Discussion on “Coupled effective stress analysis of insertion problems in geotechnics with the Particle Finite Element Method” by L. Monforte, M. Arroyo, J.M. Carbonell, and A. Gens

Jakub Konkol^{1,*}, Lech Bałachowski²

Abstract

Fig. D1. PWP distribution around the piezocone: ALE model (frictionless interface) and corresponding SCEM results. [no colour]

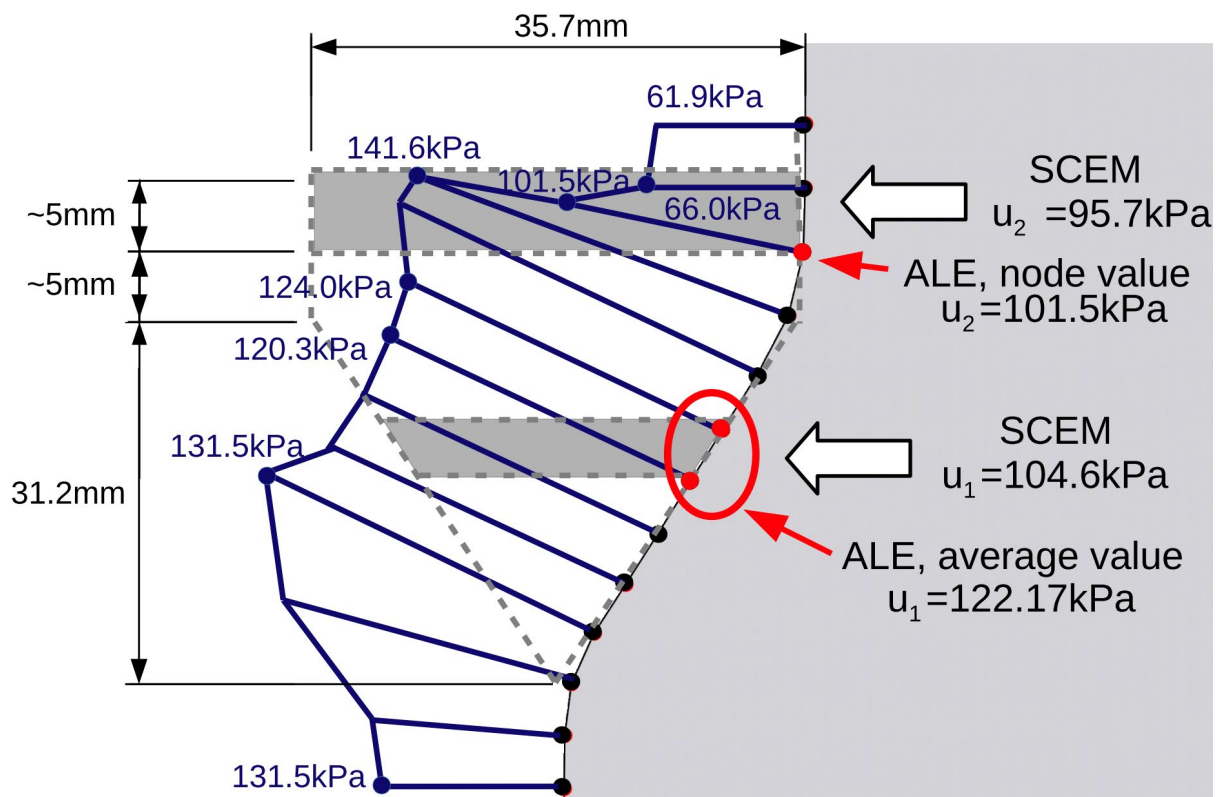
where: u = pore water pressure around the cone, Δu_{oct} = octahedral component of pore water pressure, Δu_{shear} = shear-induced component of pore water pressure, Δu_{TSP} = total stress path dependent component of pore water pressure, s = total stress path coefficient ($s=4/3$ for u_1 and $s=0$ for u_2 [6]), u_0 = initial pore water pressure, K_0 = earth pressure at rest coefficient, σ'_{v0} = initial effective vertical stress. Using compatible parameters ($G=877.32\text{kPa}$, $c_u=17.78\text{kPa}$) and initial conditions assumed by the Authors (weightless soil, $p'_0=38.57\text{kPa}$, $K_0=0.5$), one can calculate the corresponding components of the mobilized excess pore water pressure: $\Delta u_{oct}=92.70\text{kPa}$, $\Delta u_{shear}=3.01\text{kPa}$, $\Delta u_{TSP}=8.84\text{kPa}$ (only for u_1) and $u_0=0\text{kPa}$ (due to weightless soil). Consequently, the water pressures at the filter positions are $u_1=104.55\text{kPa}$ and $u_2=95.71\text{kPa}$. With $G=1306.32\text{kPa}$, one obtains $\Delta u_{oct}=101.86\text{kPa}$, $\Delta u_{shear}=3\text{kPa}$, $\Delta u_{TSP}=8.84\text{kPa}$, $u_1=113.71\text{kPa}$ and $u_2=104.86\text{kPa}$. These values are significantly lower than those presented by the Authors in Table 4. In Discussers' opinion, this could be attributed to high oscillations and variability of PWP distributions around the cone obtained with LDFEM, such as UL, ALE, MPM or PFEM. Examples of such non-uniform distribution can be seen in the Authors' papers (Fig. 8b in [2], and Fig. 2 in [8]). In Fig. D1, the Discussers present the PWP distributions around the cone from the ALE model (frictionless interface) and the corresponding SCEM solutions for u_1 and u_2 . The concentration of generated PWP is observed at the cone tip and just behind the cone. The Discussers predominantly used the average PWP value from the u_1 area (see Fig. D1). For the u_2 position, the Discussers mainly considered the PWP values close to the actual filter position or the average value from nearby points, see Fig. D1. However, due to high PWP fluctuations in this area, it is difficult to determine the actual u_2 value. This high variability is also observed for field registered u_2 measurements (e.g., Fig. 2 in [9]) or lab tests (e.g., Table 2 in [10]). To sum up, due to uncertainty in determining u_2 , the unique reference SCEM solution may facilitate the

interpretation in the cone vicinity. Discussers would like to ask the Authors for their opinion regarding the reliability of u_2 output in PFEM.

Fig. D2. Effect of interface friction on (a) cone resistance and (b) sleeve friction. [no colour]

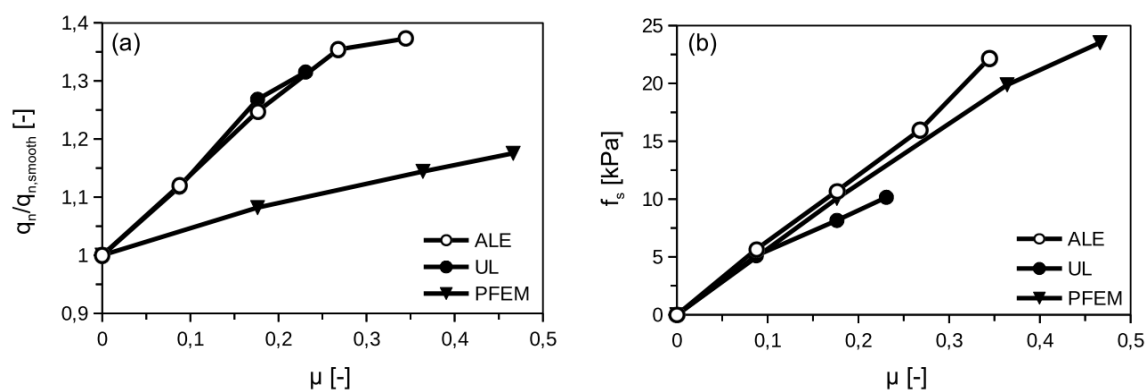
The q_n increase with interface friction is presented in Fig. D2a. The numerically simulated q_n obtained using ALE and UL is up to 40% higher than for the corresponding smooth cone and

considerably higher than the PFEM solution. The Authors suggest that PFEM and MPM give similar results when there is an increase in interface friction. They link the discrepancies with the performance of contact algorithm, although both formulations use the contact penalty method. The ALE and UL calculation results presented by the Discussers are closer to the MPM solutions [3] referred by the Authors. This may suggest that the friction component of the cone resistance is underestimated in the PFEM.

Fig. D2b presents sleeve friction increase in relation to interface friction. Here, UL, ALE, and PFEM give almost the same results. However, this to some extent contradicts the cone resistance results (Fig. D2a) and the Discussers would like to ask the Authors for their opinion regarding the contact algorithm performance.

Fig. D3. Effect of interface friction on PWP at (a) u_1 , (b) u_2 and (c) u_3 . [no colour]

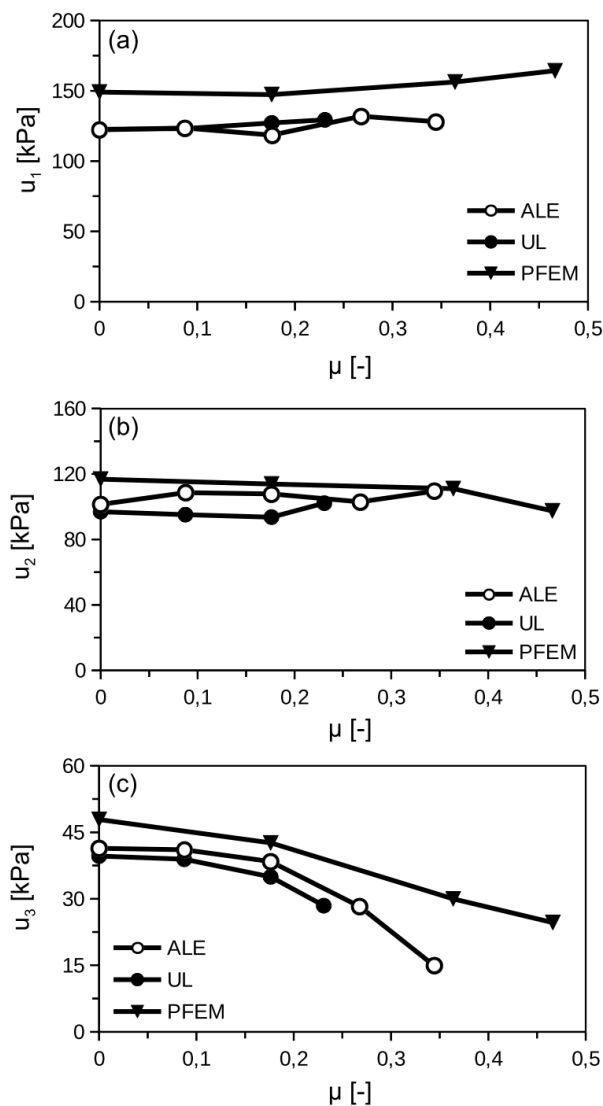
The Authors' analysis of pore water pressures developed around the cone due to different interface friction seems to be incomplete. Of the provided values u_1 , u_2 and u_3 (in Table 4), only the results of u_2 position are discussed. A comparison between the Authors' and the Discussers' results is presented in Fig. D3. The discrepancies for the u_2 position may be related to the PWP nodes used in the analysis. This issue was already addressed in section 2. The PWP around the cone (in u_1 and u_2) seems to be independent of the interface friction. The

research shows that only the u_3 position seems to be slightly influenced by interface friction when $\mu < 0.2$. For higher μ values, this effect is more important.
